Access Compliance Report

Public Rights-of-Way

(Curb Ramps)

Intersection ID: 10447	Main Street: SYLVANIA_AV	Cross Street: BANCROFT_ST	Location: NE
ADA ID: 15D0C8696EF6	Ramp Type: PerpDiag	Initial Pass/Fail: Pass	Overall Compliance: No
		Severity Score: 7.5

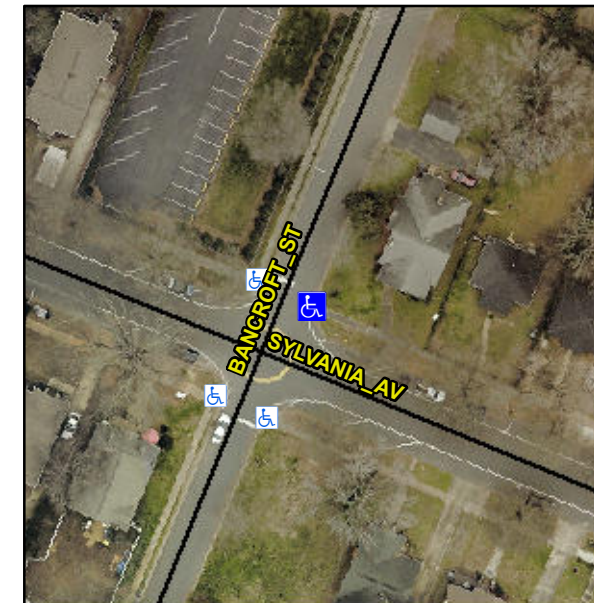
Not Found, R304.2.1, R302.7.2

Remove & Replace Curb Ramp With Two New Directional Ramps or Equivalent.
